Fm ~~TO:~~ Doug Martin, Light & Power
~~TO~~ *FROM:* Randy Maizland, Development Review Engineer *RM*
DATE: June 21, 2006
RE: REQUEST TO VACATE RIGHT-OF-WAY

Re: Request to Vacate Right-of-Way – Oak Street

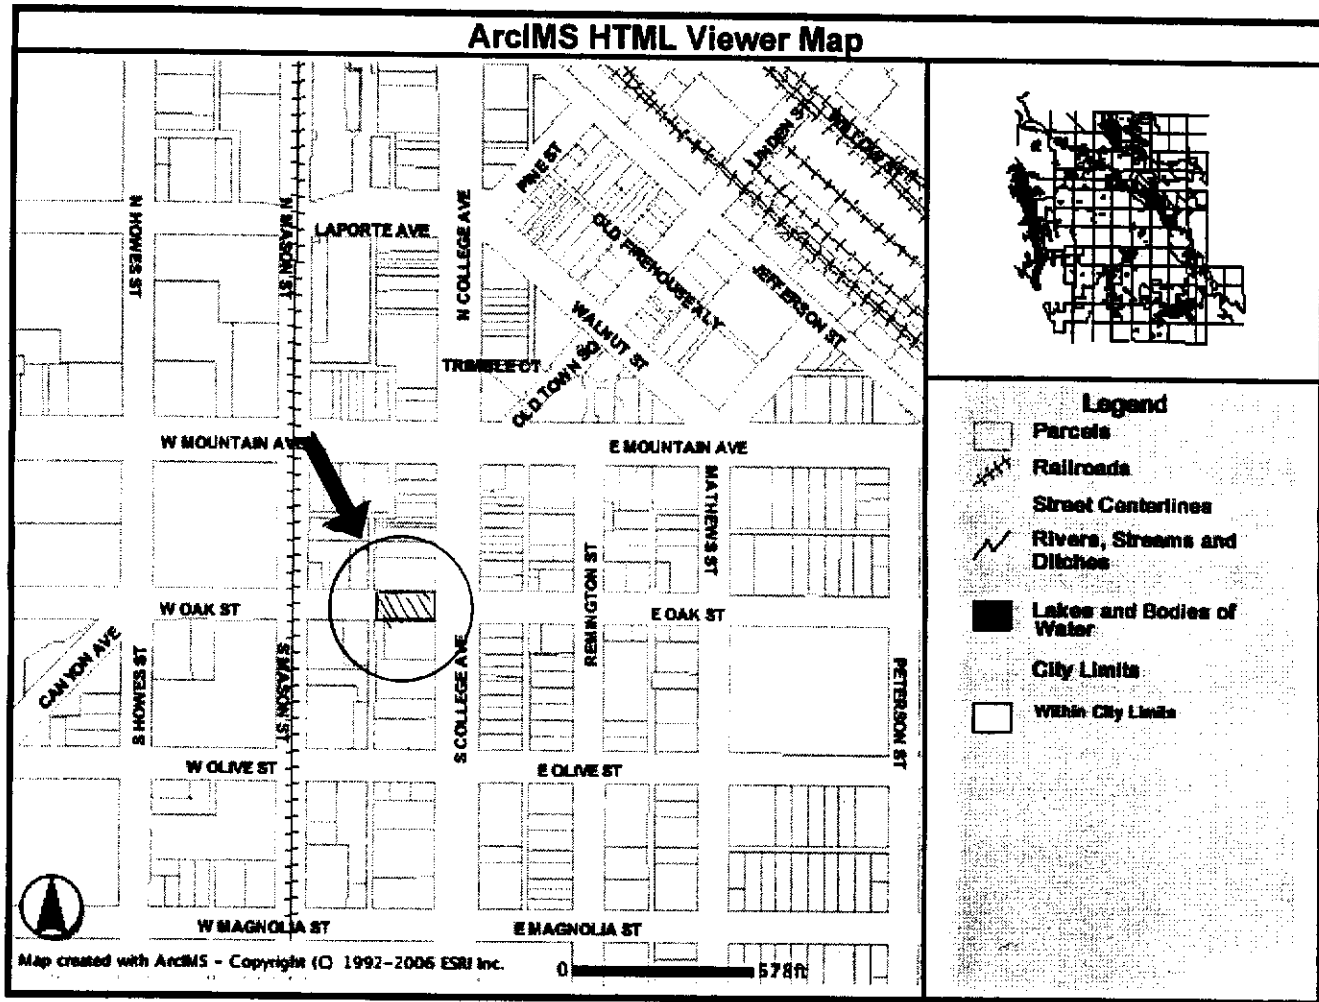
*THERE IS A SAN. SEWER IN THE
N/S ALLEY & A SEWER SVC.
THAT EXTENDS TO THE
FOUNTAIN AREA.*

Per my phone conversation with Randy Maizland on 6/27/06 the area on the map that has hatch lines in it will be the new utility easements which would be OK with Comcast as long as they are labeled on the map as Public Utility Easements.
I would also ask that there be a utility easement shown for the Plaza Internet Data line.

1. The first comment is that it is hard to tell if sheet U-1 is correct since the only reference to anything existing is the street Right-of-Way which I have no idea how it relates to anything physical in the field. On the west end there is no indication of where the Park Plaza Property is, not even a dimension from the east end.

2. It doesn't appear the storm sewer is shown in the correct place. I have included the as-built plans for the project. There are dimensions for the location from the flow line but nothing to reference the Right-of-Way.

3. The 20 foot indicated by shading centered on the storm sewer line is a minimum width for small pipes at shallow depths. For this size of pipe I recommend the entire Right-of-Way be the drainage easement. It will take all that room if the pipe needs to be dug up for repair. The other option we often offer is that the easement can be the width needed using OSHA criteria for the trench width and slope to the surface. That is usually a foot either side of the pipe and a 1 to 1 slope to the surface from the spring line of the pipe. The plan and profile sheets will give the design engineer a depth to use for calculation of the trench width needed for the 78 inch pipe. Again it would be best to retain the entire street Right-of-Way which the calculations may show is needed anyway since the bottom of the pipe is 18 ft. (+/-) deep.

4. Please label the storm drainage easement, shading is not very definitive.
5. There are 18 and 30 inch storm sewer laterals running north and south off of the 78 inch main storm sewer to inlets at the west end of the Park that all need to be in easements.

6. There is a 48 inch storm sewer at the east end of the Park running north along the west side of College Ave. that needs to be in an easement. Again these could all be covered if the entire Right-of-Way was a drainage easement.
